**NEBRASKA ARMY NATIONAL GUARD
SEWARD MUSEUM REMODEL – PHASE 2**

PROJECT NO. 31030123

A D D E N D U M N O . 1

REF. SHT# C1.1

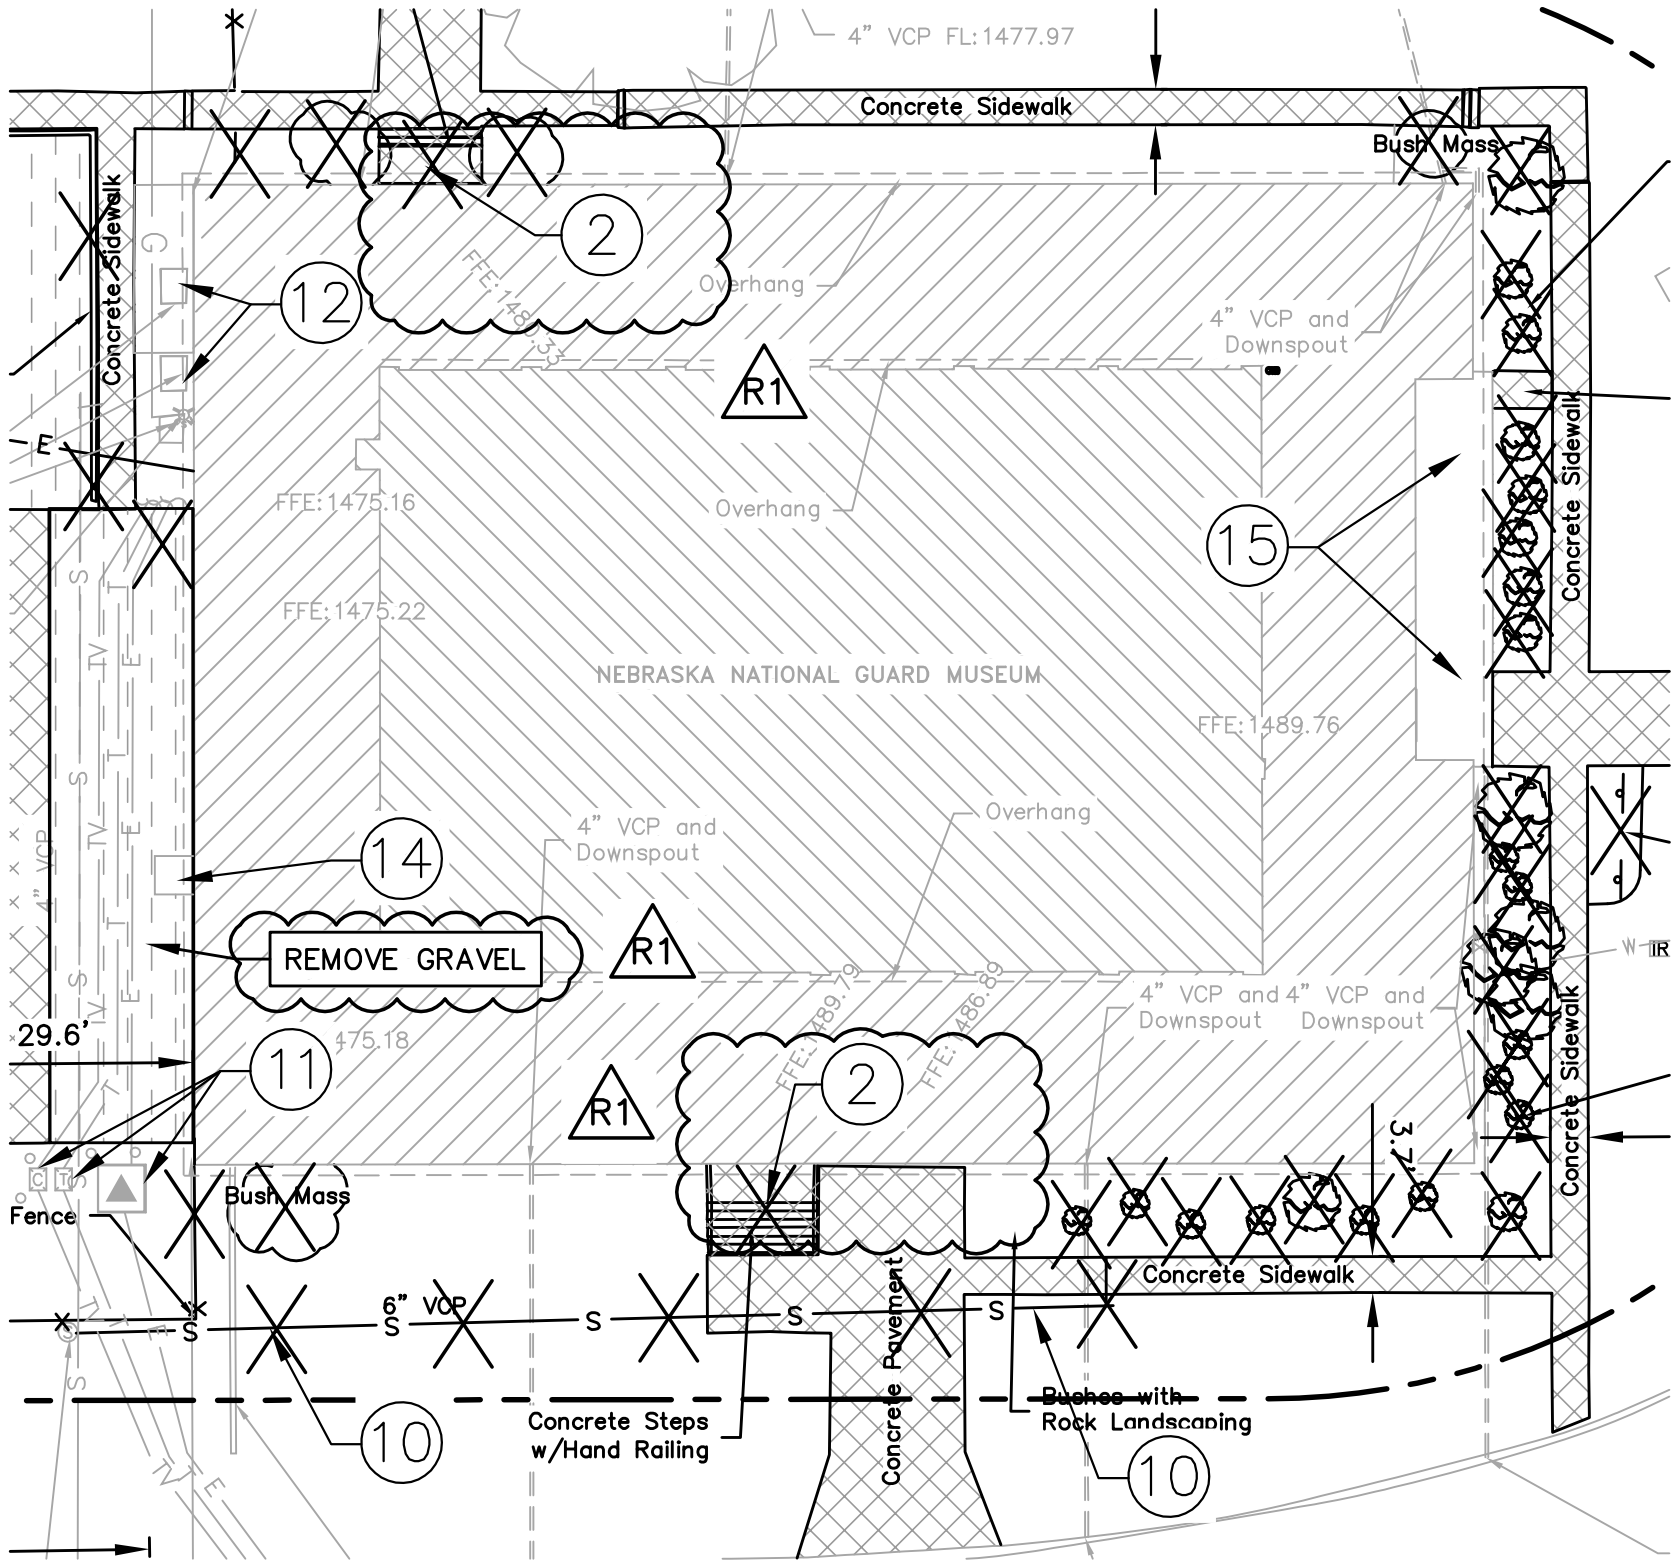
- ADD 2-1 Sheet C1.1.
 - 1. Revise: Clarification of demolition items (attached).
- ADD 2-2 Sheet C1.2
 - 1. Add: Callout notes to handicap stalls, added precast wheel stops for gravel parking lot (attached).
- ADD 2-3 Sheet C1.3
 - 1. Add: Spot grades (attached).
- ADD 2-4 Sheet C2.1
 - 1. Add: Detail Number 9 (attached).
- ADD 2-5 Sheet AD1.1.
 - 1. Reference detail N3.
 - a. Remove CMU block pattern from two rectangles below the clerestory window. These rectangles represent the penetrations for the ductwork from the new HVAC rooftop unit through the exterior wall.
 - 2. Reference detail A12.

ISSUED FOR:	DATE:	BY:
REVISED REMOVAL INFORMATION NOTE #2. REVISED REMOVAL INFORMATION NOTE #3, ADDED REMOVAL INFORMATION NOTE #2 TO DEMO LAYOUT PLAN.	08/18/14	SDB

SEWARD MUSEUM REMODEL PHASE 2 ADDENDUM #1 - DRAWING 1

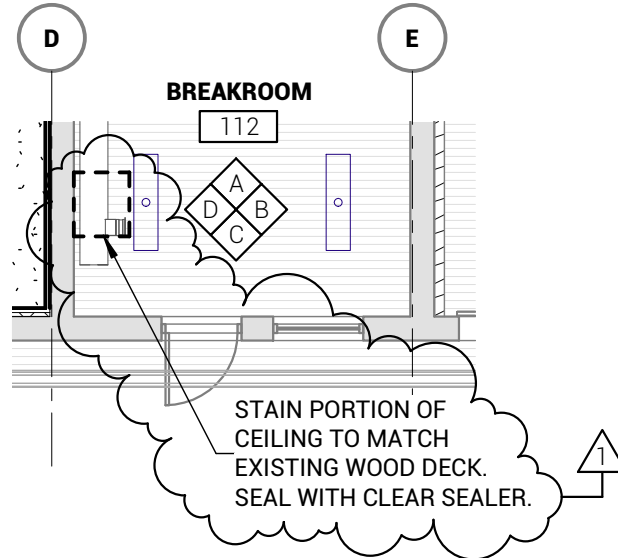
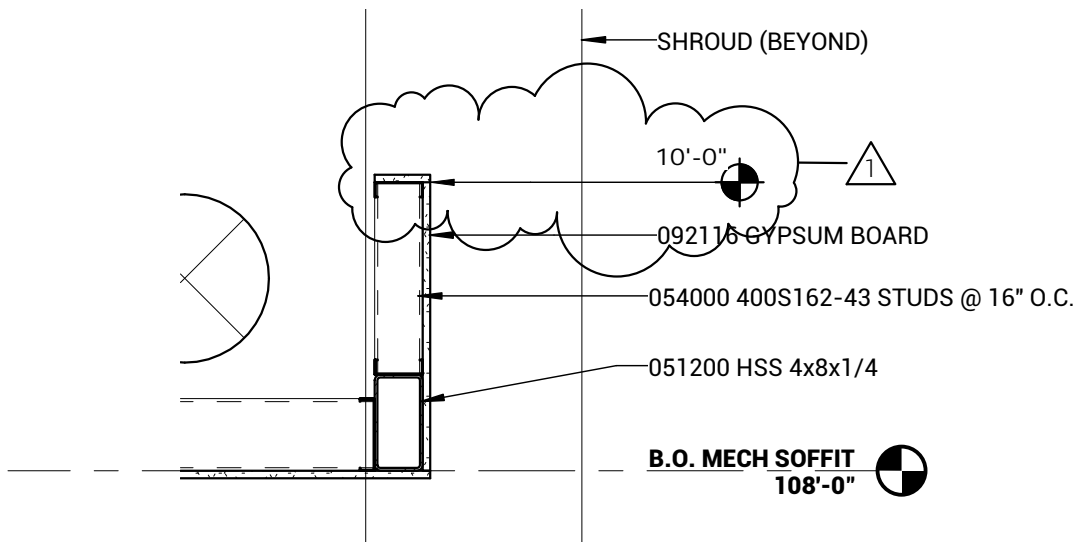
1. Reference Door Schedule.
 - a. Change fire rating of Door 107 to 60 minutes.
 - b. Delete columns labeled "Glass Type, Head, Jamb Left, Jamb Right, Sill" from schedule.
2. Reference detail A13.
 - a. Remove detail symbol from Coats 120B.
 - b. See drawing 1-detail A13R/A6.1 to stain existing wood decking in Room 112.

- a. See drawing 1-detail P1R/A6.1 for changes shroud height.
 3. See drawing 2-detail T20 for new soffit detail.
 4. Reference detail A7 and A1.
 - a. See drawing 3 and drawing 4 for changes to shrouds.

SEWARD MUSEUM REMODEL PHASE 2 ADDENDUM #1 - DRAWING 2

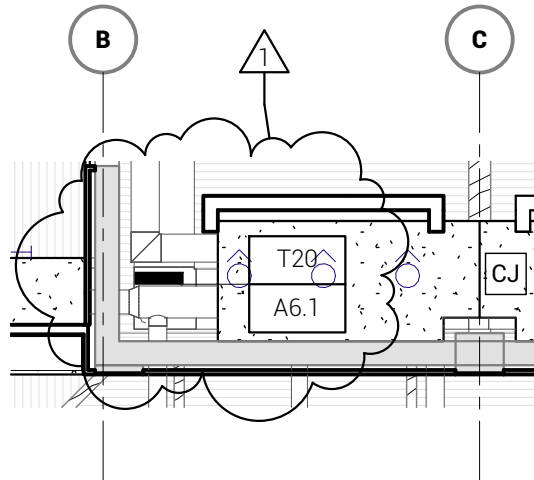
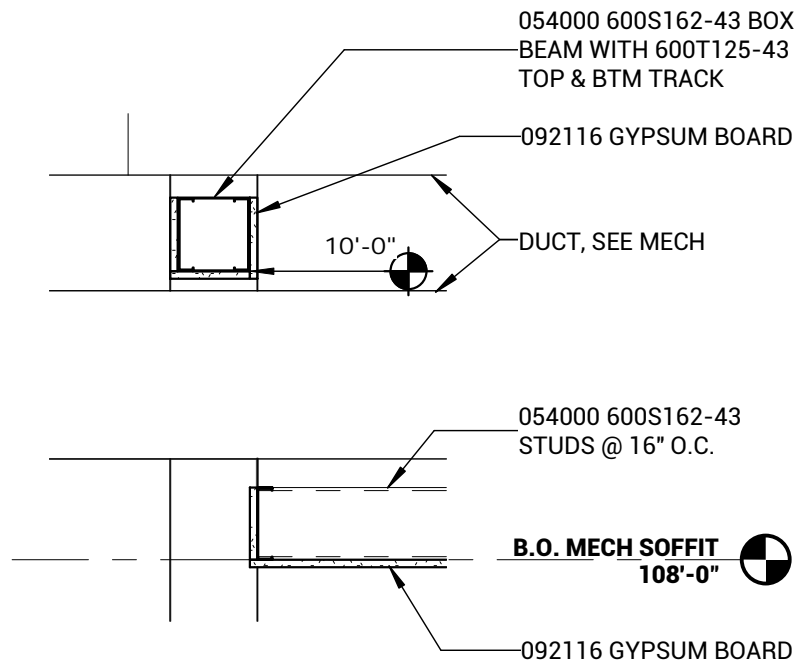
- c. See drawing 2-detail A13/A2.1 for new soffit detail at end of shrouds. Typical at southwest shroud and west shroud.

A1R/A1.0A ARCHITECTURAL SITE PLAN - BASE BID

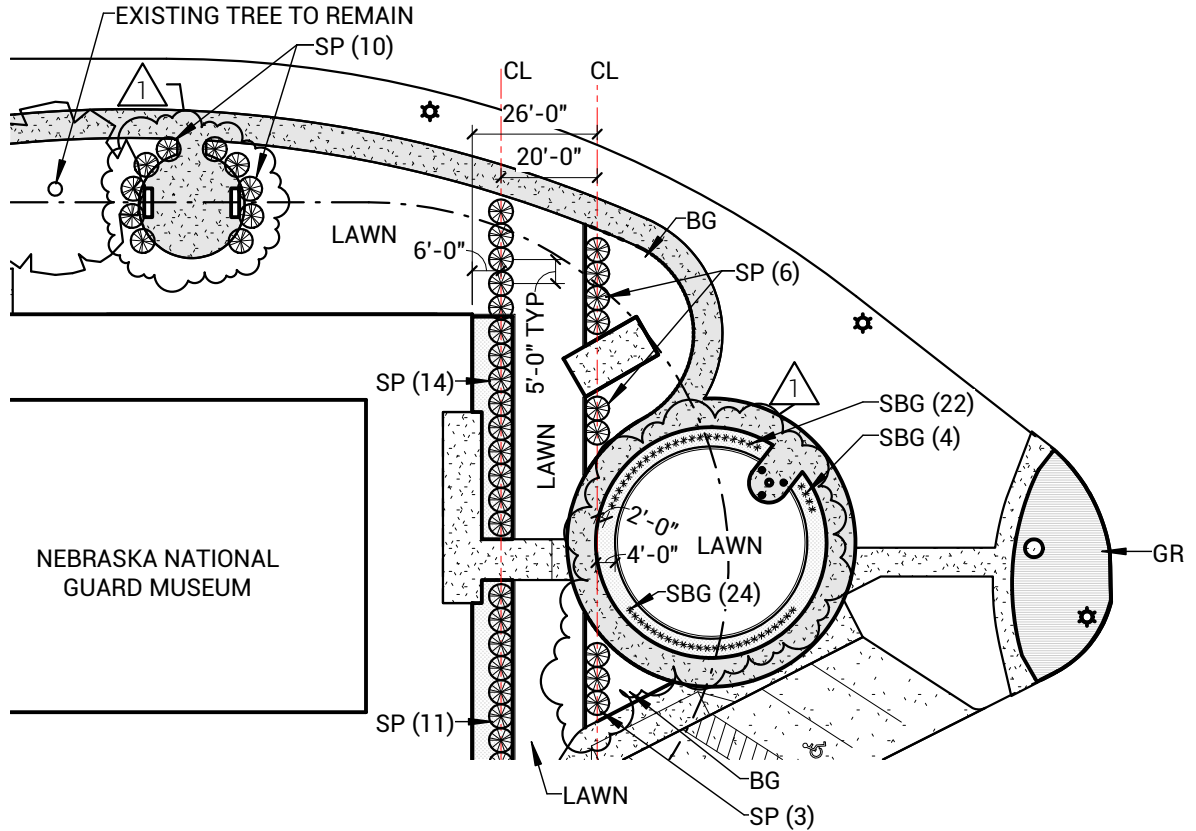
1. Reference Planting Schedule-Base Bid.
 - a. Plant type SBG-Sand Bluestem Grass shall be provided in 1 ½ gallon containers.
 - b. See drawing 5 for changes to Landscape Plan.

H12R/A5.3 RECEP. DESK - PLAN

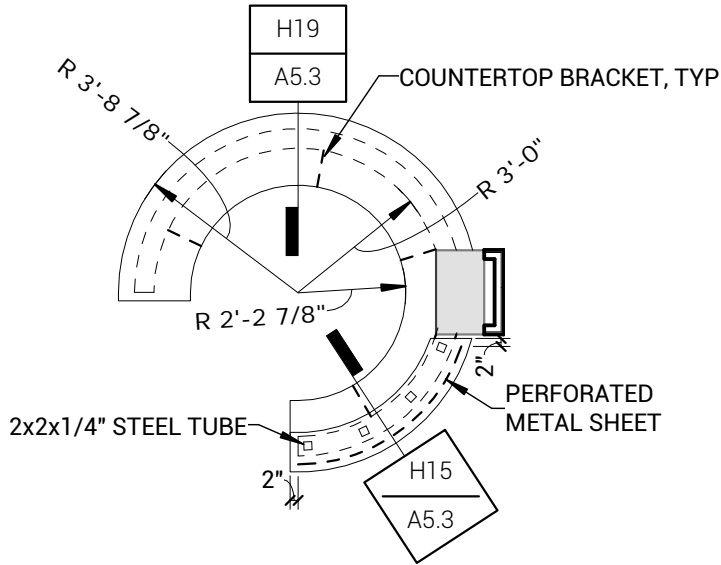
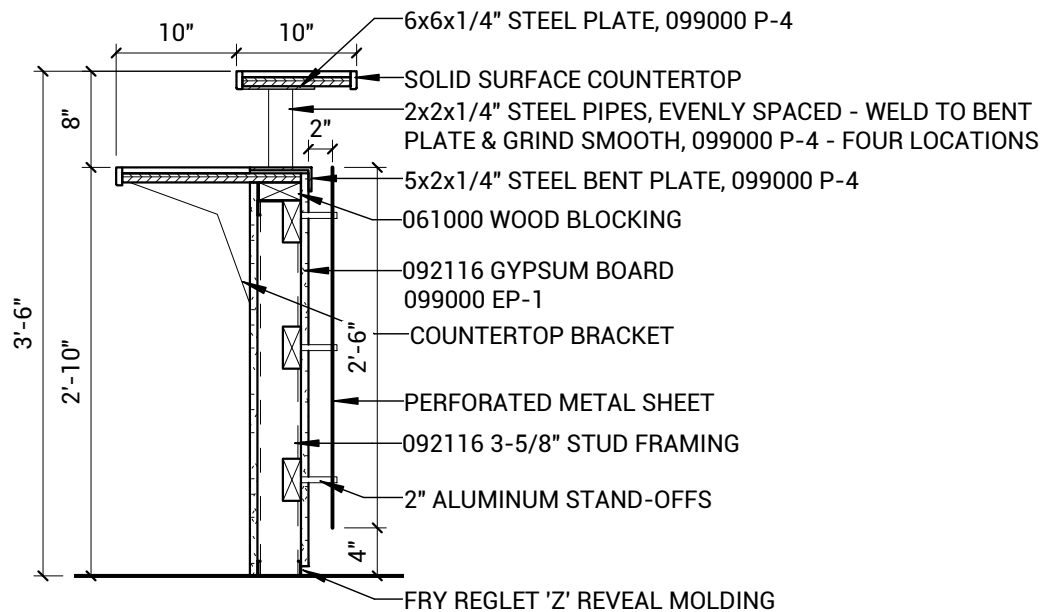
- ADD 2-14 Sheet A5.3.
1. Reference details H12 and H15.
 - a. See drawing 7 for changes to reception desk details.
 2. Reference detail H22.
 - a. See drawing 9 for revised detail.

A1R/A5.2 SECTION DETAIL - NORTH STOOP

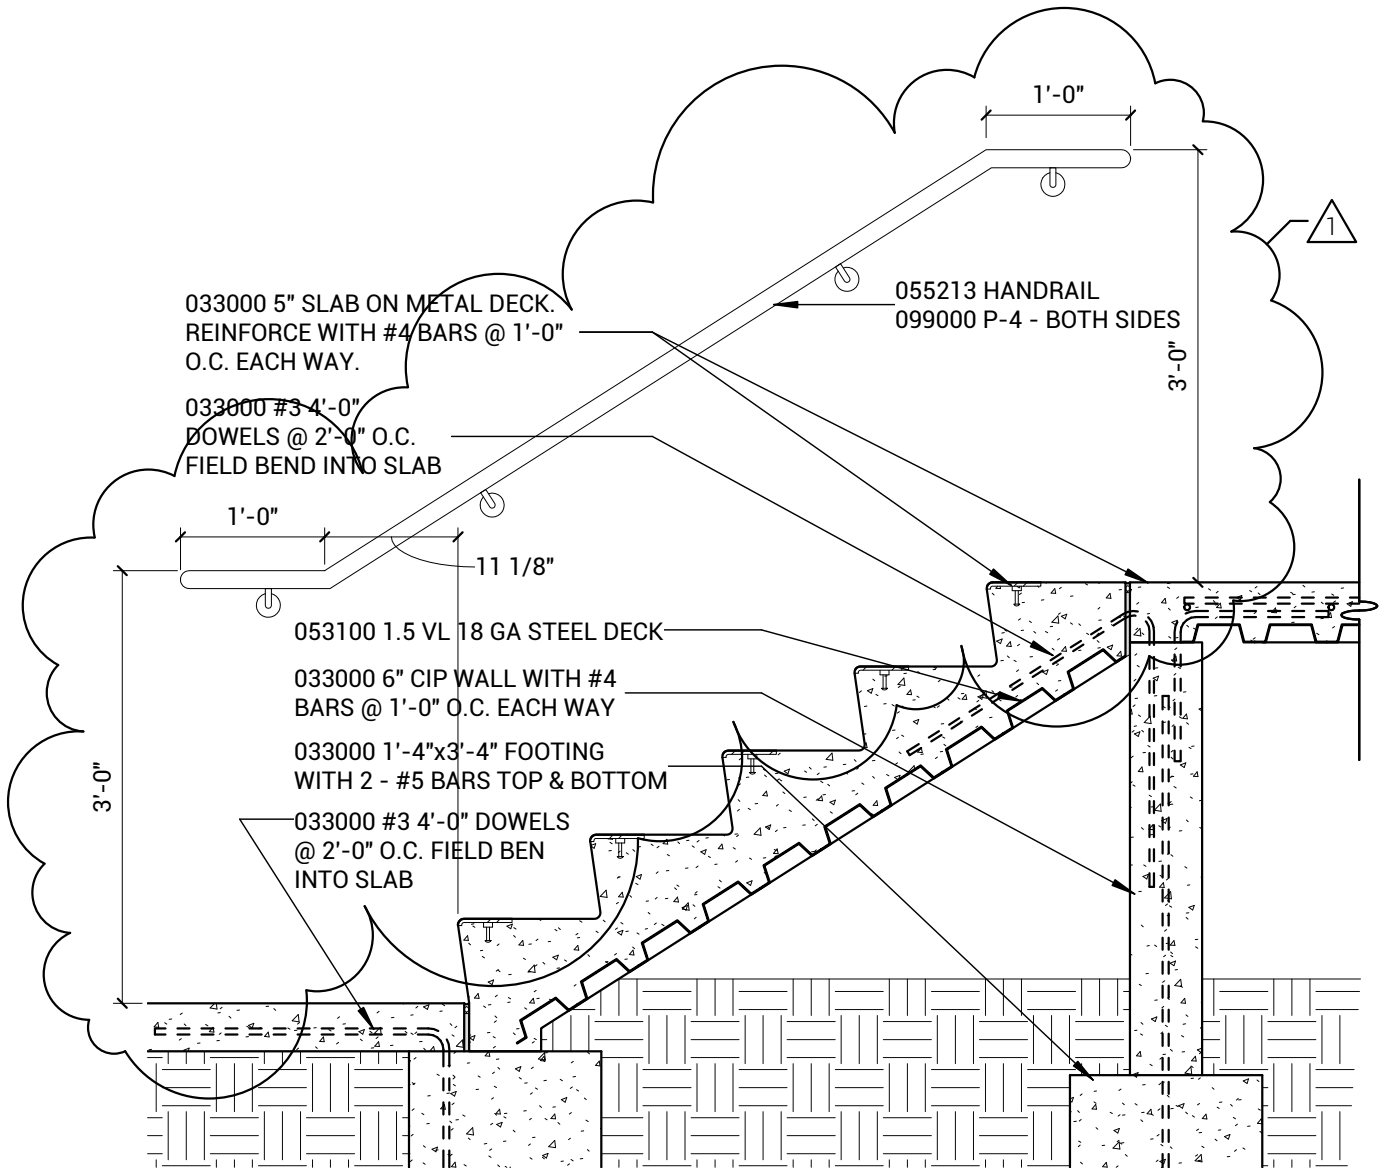
- ADD 2-13 Sheet A5.2.
1. Reference detail A1.
 - a. See drawing 8-detail A1R for wall rail elevation.
 2. Reference detail F1.
 - a. See drawing 14 for changes to guardrail detail.

H22R/A5.3 COAT ROD

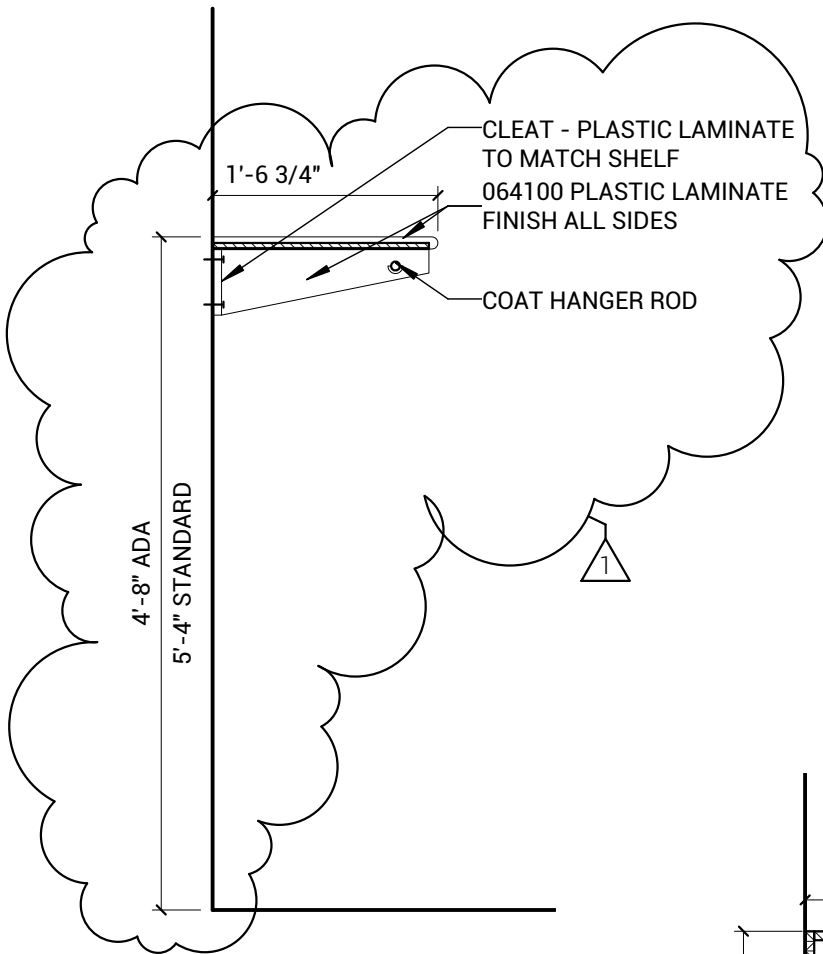
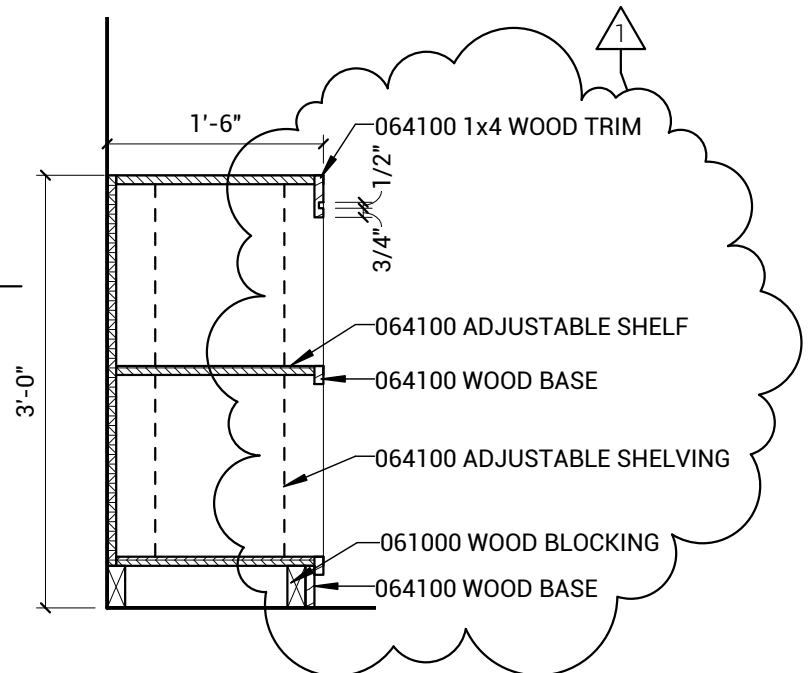
3. Reference detail A18.
 - a. See drawing 9 for revised detail.
 4. Reference details A10 and A15.
 - a. Change keynote number 062000 to 064100 in both details. Maple Veneer Plywood still applies.

A12R/AD1.1 FIRST FLOOR PLAN - DEMOLITION

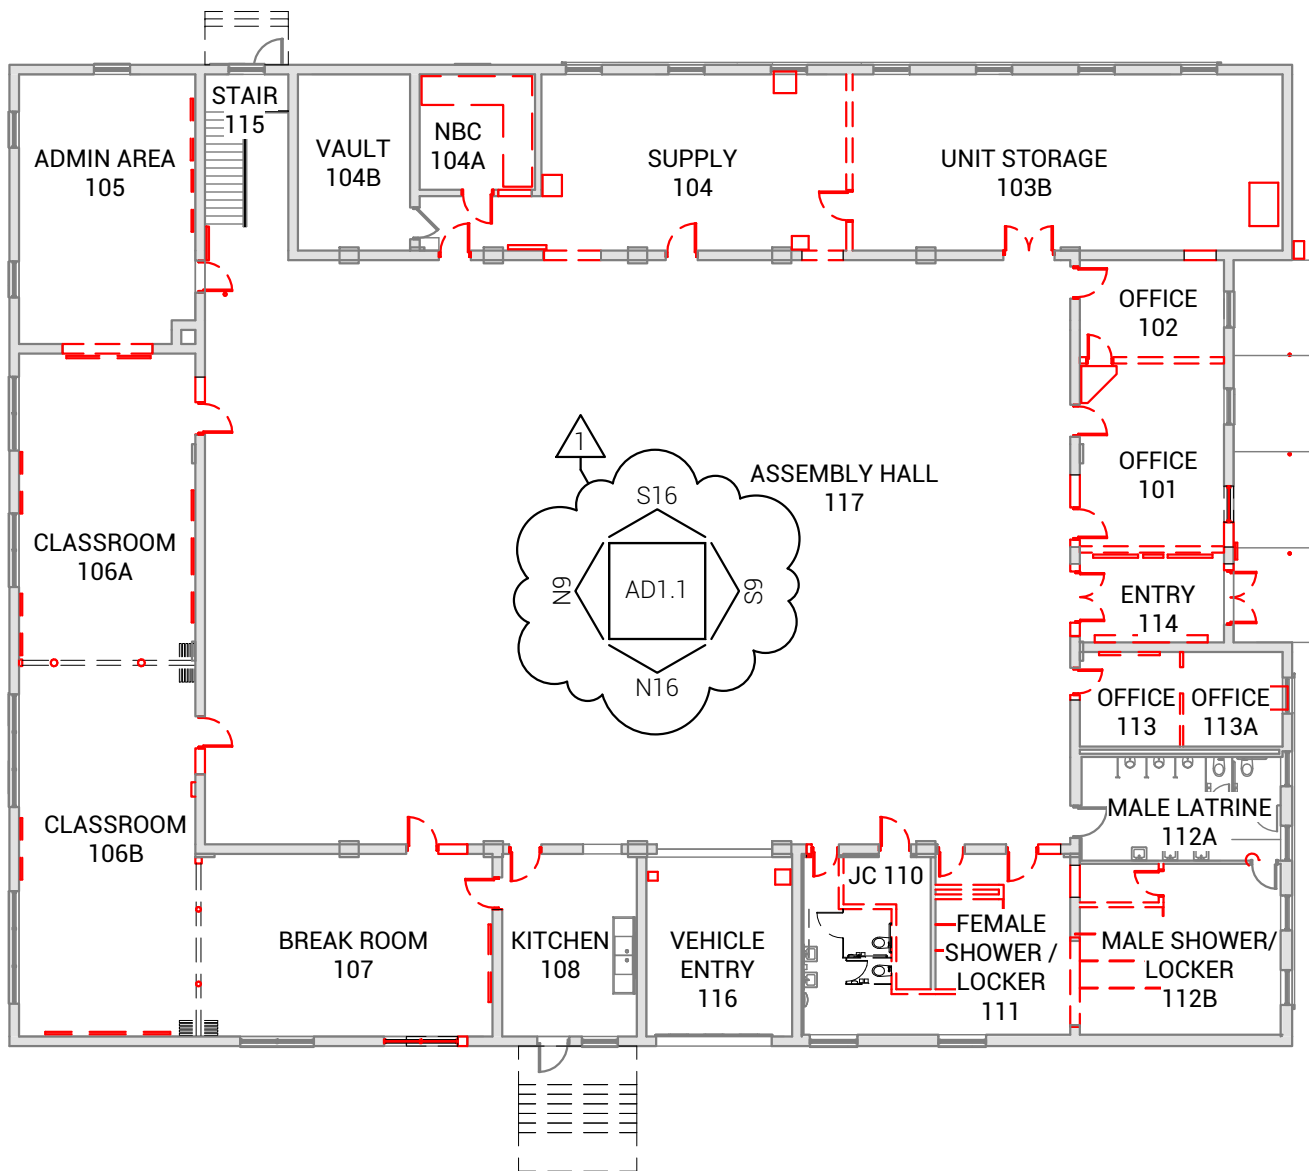
- a. Remove notes 3 and 4 from the General Demolition Notes. These notes shall apply to new work on the new floor plan rather than demolition work.
- b. See drawing 10 for addition of wall elevation tags to Demolition Plan.
